# **Remedy Optimization Team Report for the Bethpage Groundwater Plume Remedy**

**The Technical Team for Optimization of the Bethpage Plume Remedy**

**Naval Facilities Engineering Command Mid-Atlantic**

June 15, 2011

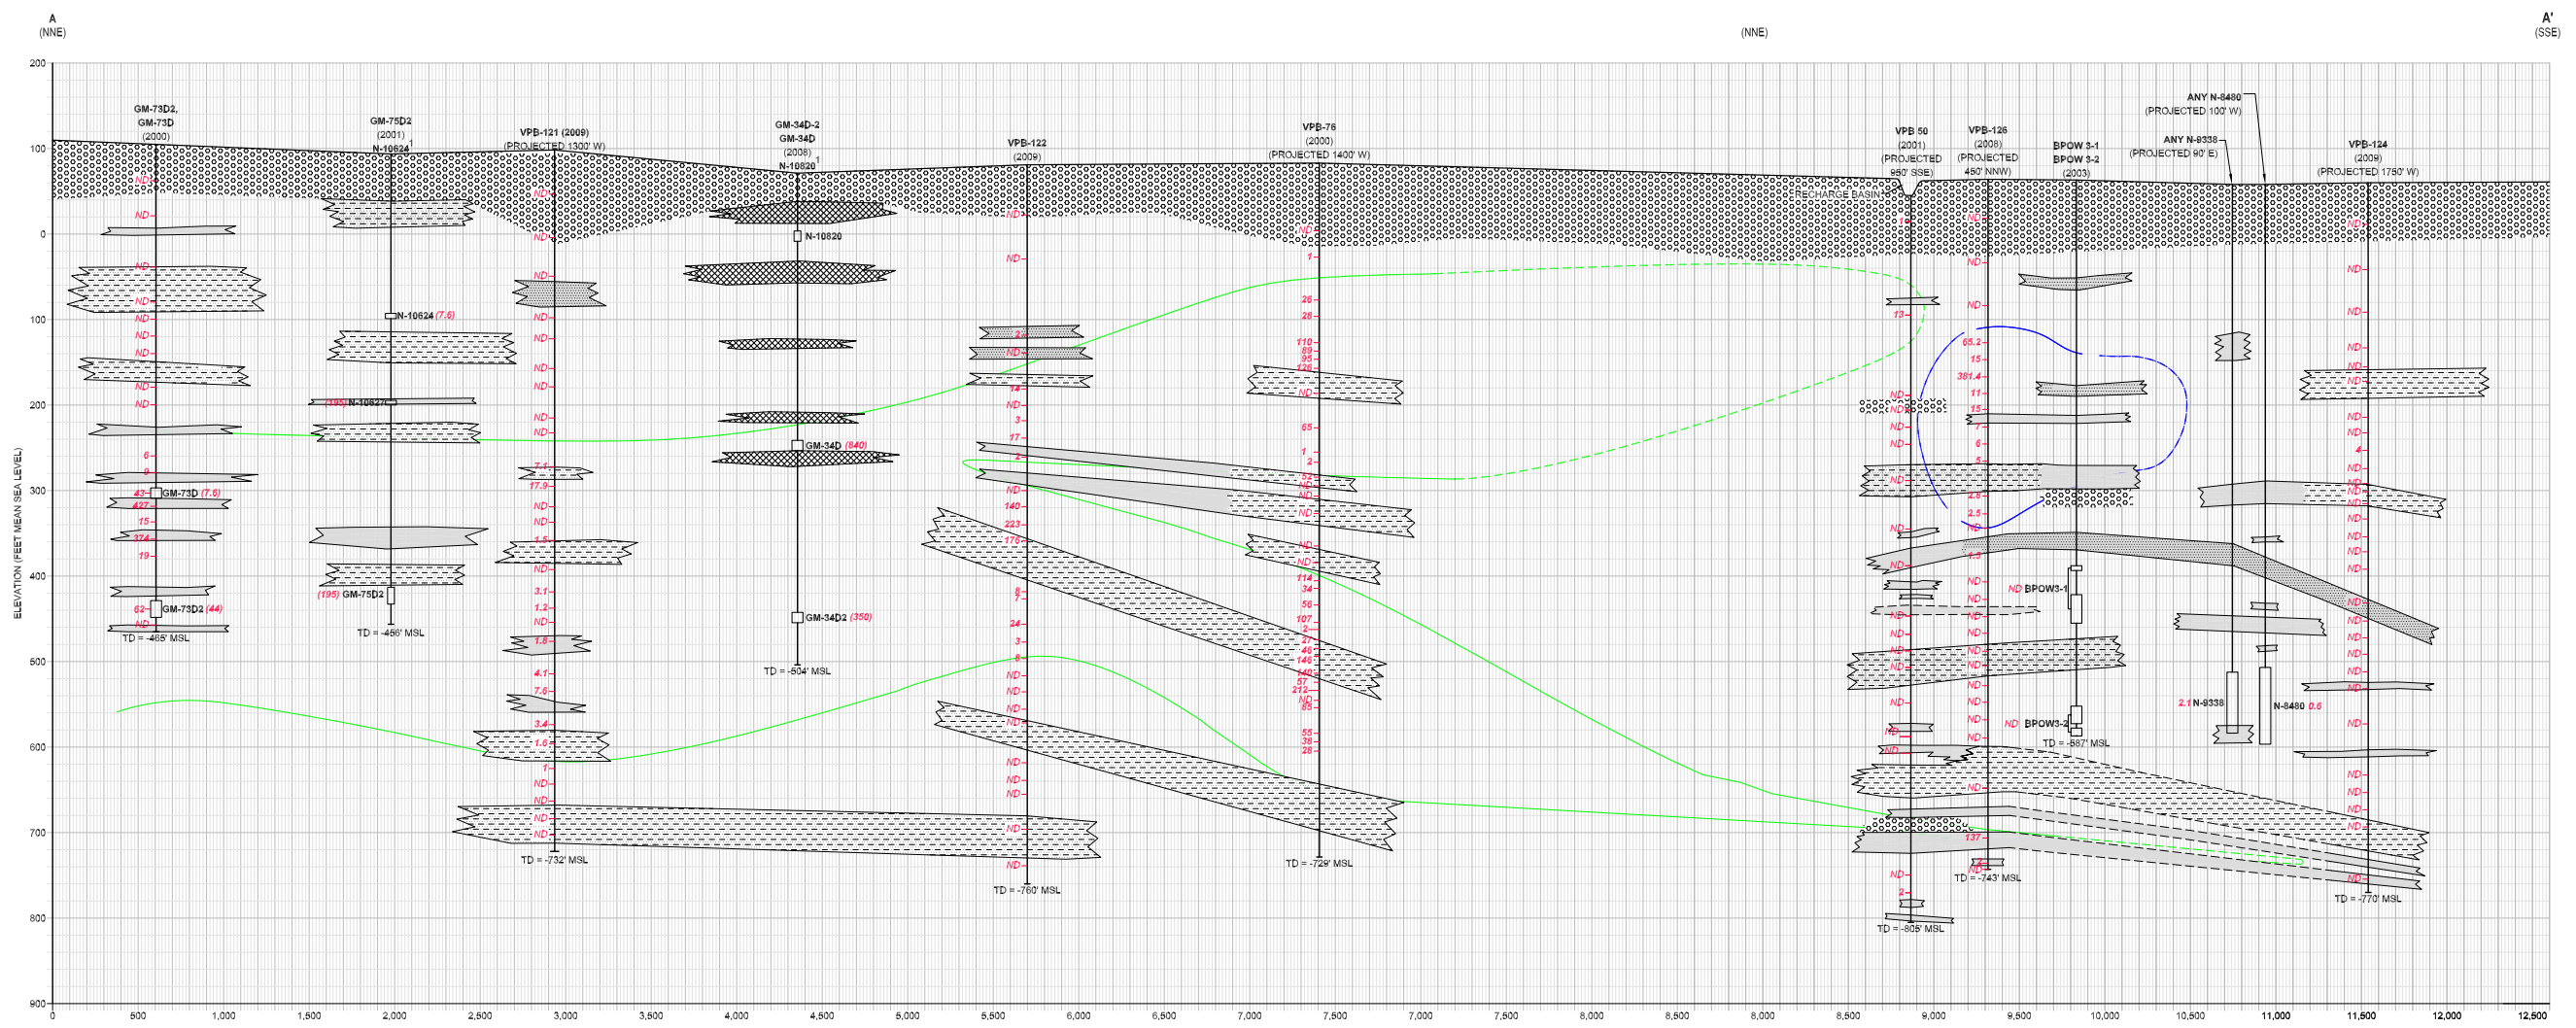
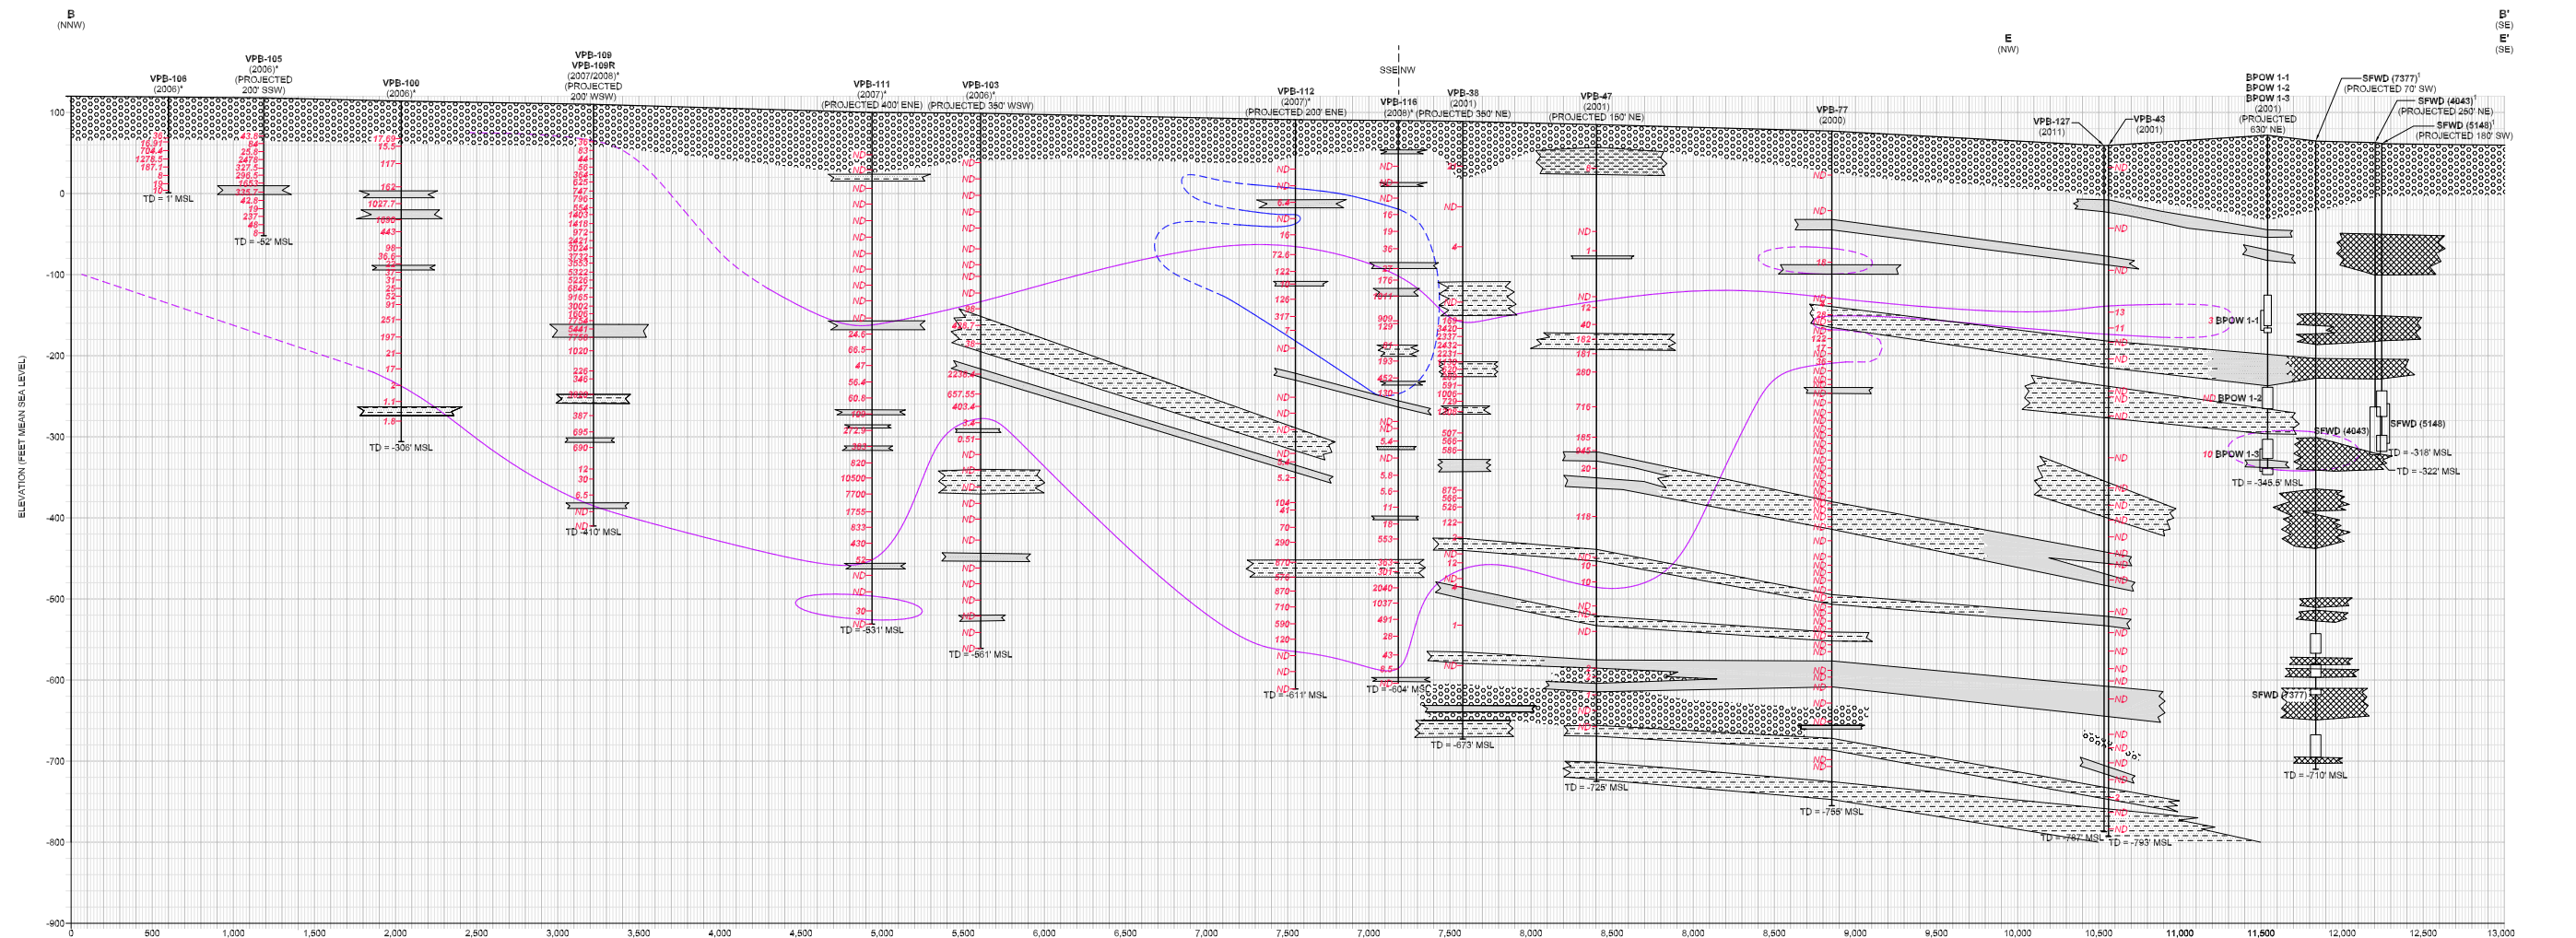
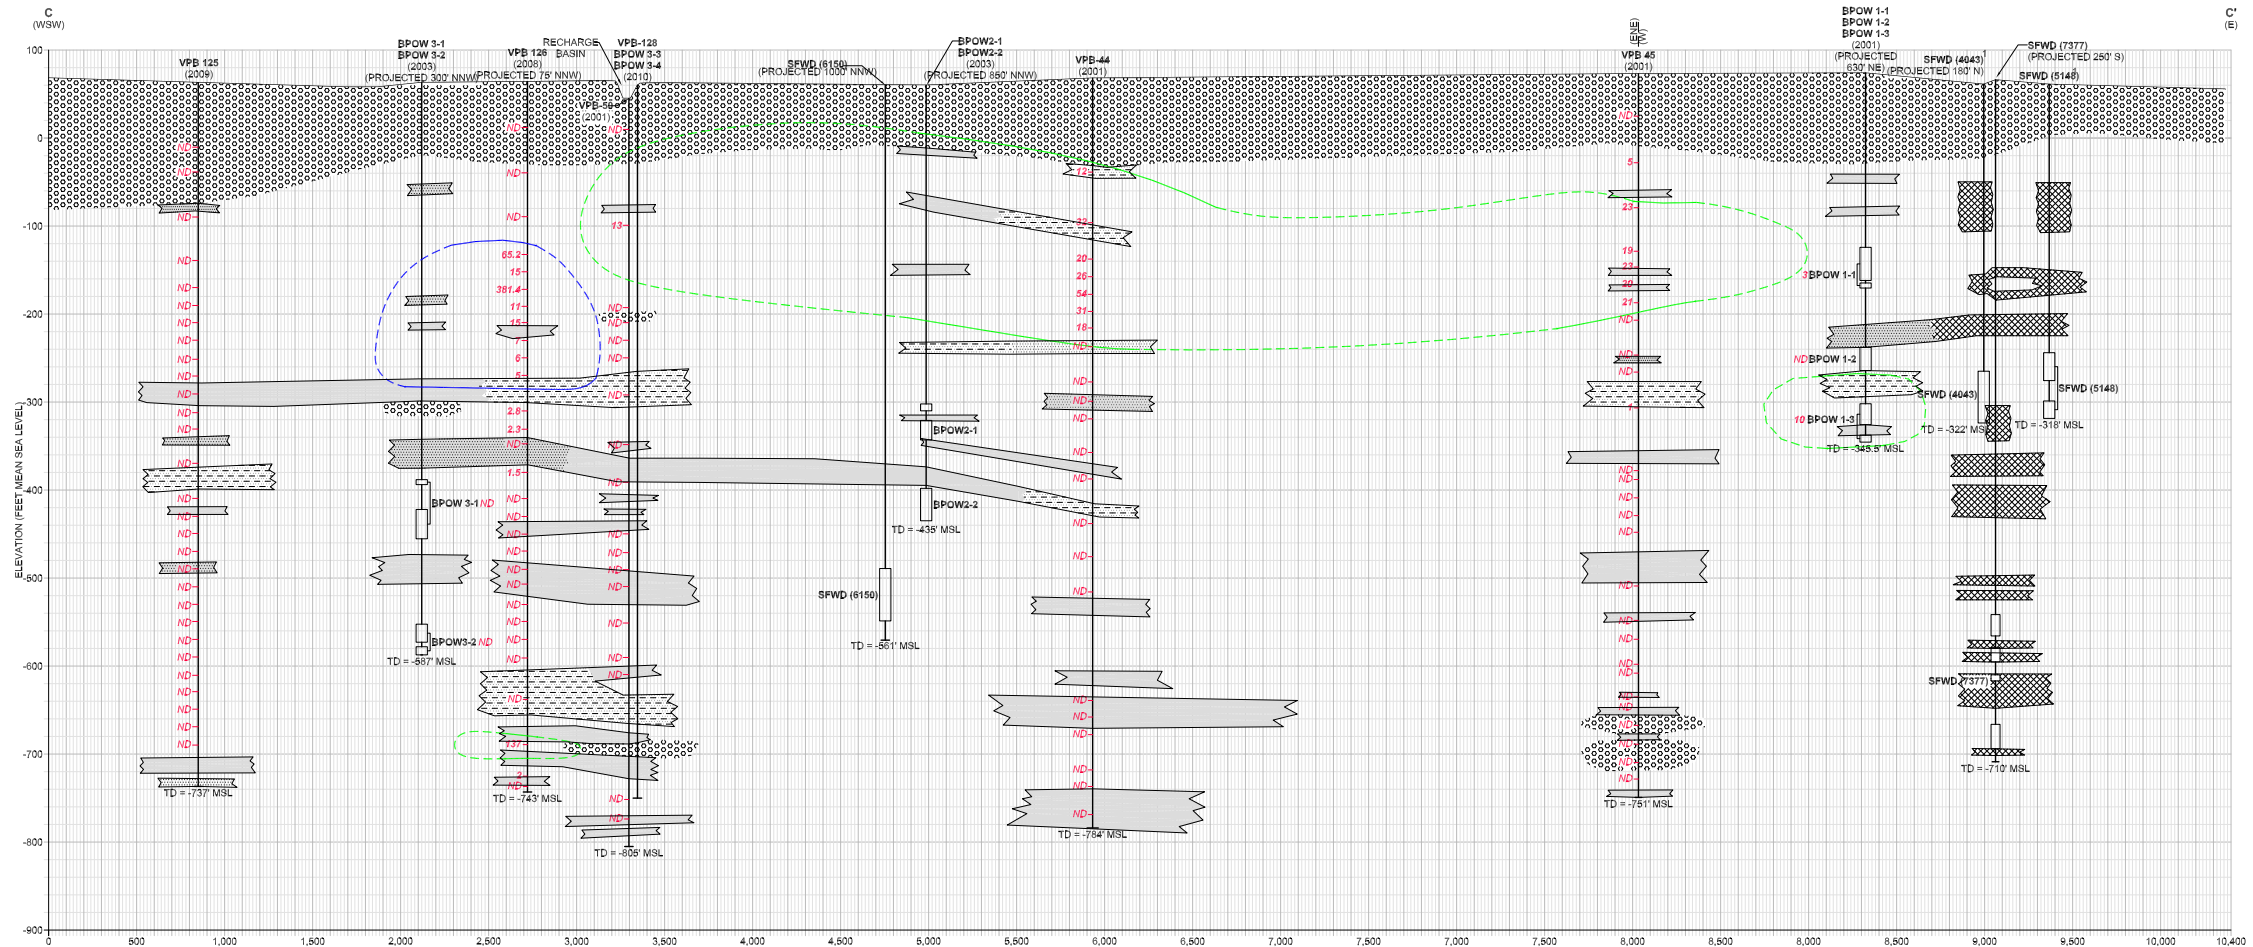
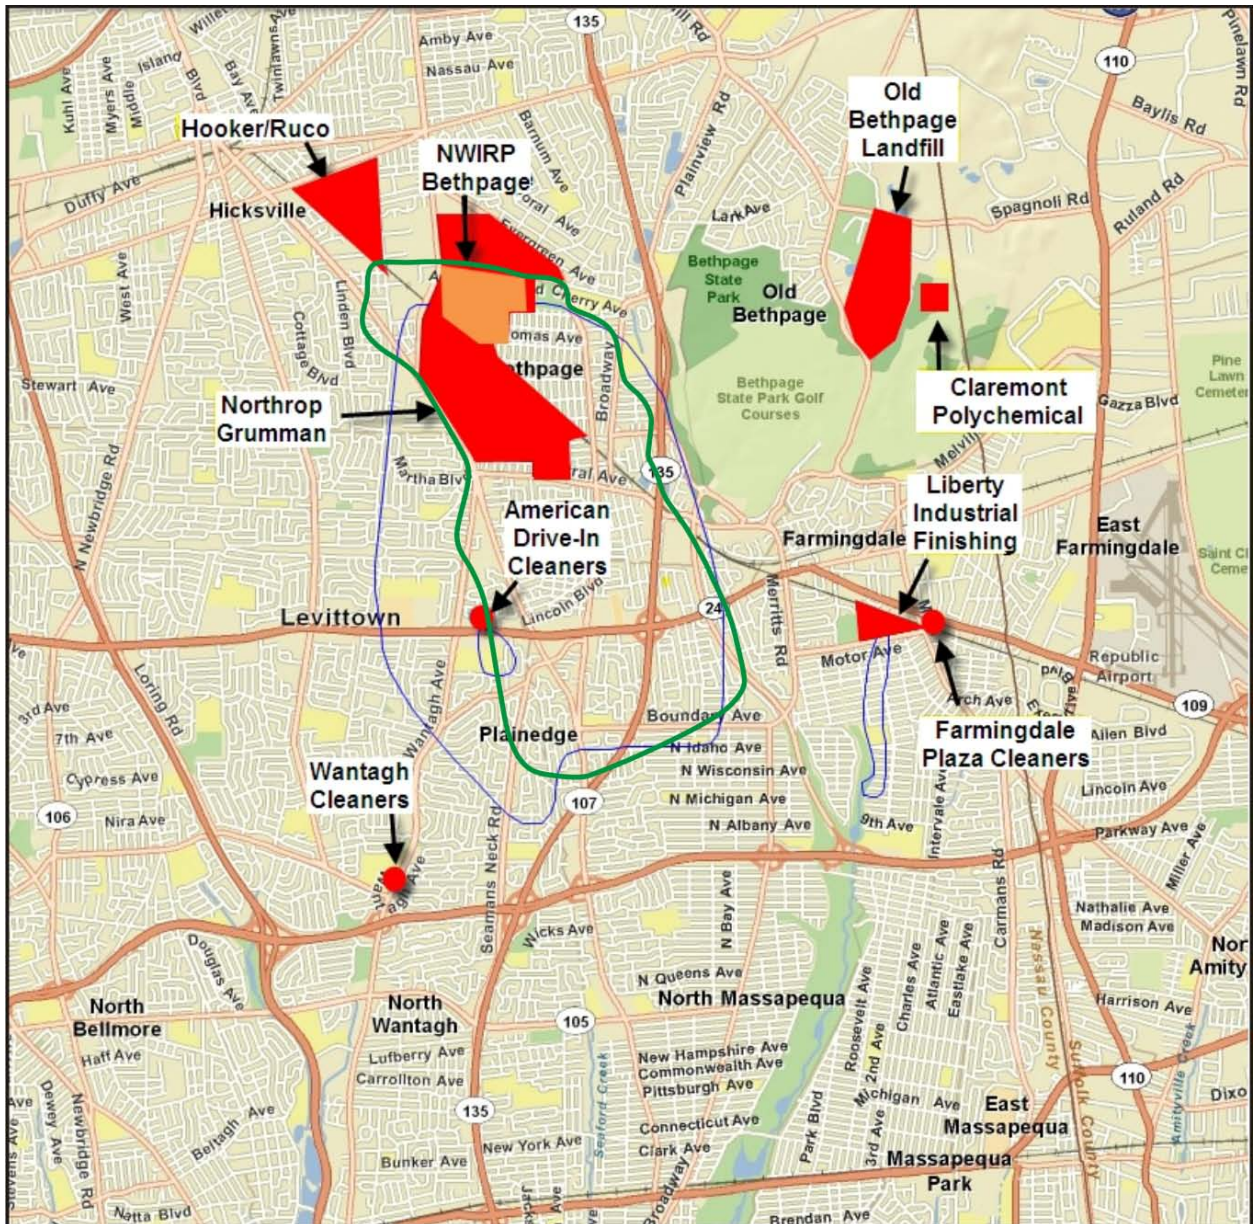
15	<p><b>6: Lithological Cross Sections (Appendix B)</b></p>	<p>Comment noted. The Technical Team agrees that limited spatial data are leading to uncertain interpretations of geologic units. This has been and will continue to be one</p>

Comment Number	Comments	Response
	<p>A number of the interpretations of low-permeability units appear to be inaccurate and not consistent with the depositional environment of the Magothy formation or the findings of the USGS and others that zones of low permeability are, for the most part, laterally discontinuous. For example: 1) some low permeability units show no dip; 2) other units show a steep dip; 3) other units arch upward; 4) various lithologic descriptions are correlated as one continuous low- permeability unit; and 5) relatively thin units are interpreted to be continuous over considerable distances. Also, the cross sections present an overly-simplified plume depiction. More detailed contouring of VOC concentrations may lead to a better understanding of plume stratification and potential sources, especially on Section B-B'. The Study Area RI Report provides a detailed analysis of VOC concentrations along a line of section similar to Section B-B' (Figure 5). Also, as stated in the Navy Work Plans, the objective of drilling to depth and mapping the upper surface of the Raritan Confining unit does not appear to have been achieved.</p>	<p>of the inherent limitations in understanding and/or modeling the groundwater flow and VOC transport at this large and complex site.</p> <p>The following additional information was provided by Tetra-Tech, the Navy contractor:</p> <p>“We acknowledge the general theory on the depositional history of soils on Long Island, as well as the general basis for the formation of low permeability units. This general theory provides a good starting point for understanding groundwater flow in the area. However, based on site-specific information, many localized variations in the general theory have been identified. In particular, based on very detailed work done on Navy property, clay units have been identified as flat (especially when viewed along the strike), steep, or even upward. The low-permeability units presented on the cross section are based on a very detailed evaluation of site-specific information and provide a good basis for understanding potential and actual groundwater and contaminant flow through the area. Where multiple borings show the same lithological signature, the units are shown as connected on the cross section. We recognize that this level of granularity would seriously limit the ability to accurately model groundwater and contaminant transport in the area, but present it because of the need to identify potential contaminant migration.</p> <p>The level of detail on the VOC contouring is likewise accurate based on the data available. This evaluation utilizes the location of known contamination and potential groundwater flow. In addition, where groundwater data are conflicting or variable, the mapping uses a conservative approach, especially where the presence of VOCs may vary based on time. For example, a water district supply well may pull contaminated groundwater from the east, west, or even south under a continuous, semi-confined seasonal pumping scenario. This condition was documented during the testing of GM-38 System, Recovery Well No. 2, where the pumping test was affected by the operation of BWD Plant No. 4.”</p>
